Pre-Application Conference

Subject: Proposed pedestrian trail along the Willamette River east of Willamette Park (south of Volpp Street)

File No: PA-14-13

Date: March 6, 2014

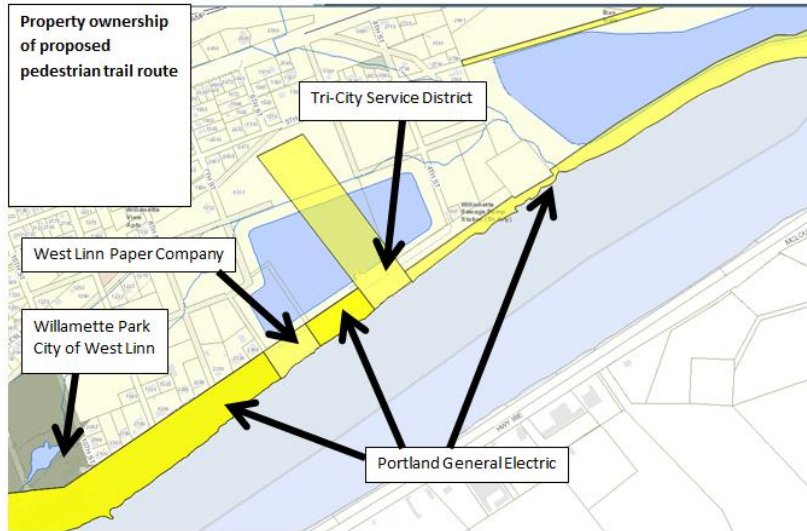
The illustration below is from the 2005 application and gives a reasonable approximation of the design we can expect with this application.
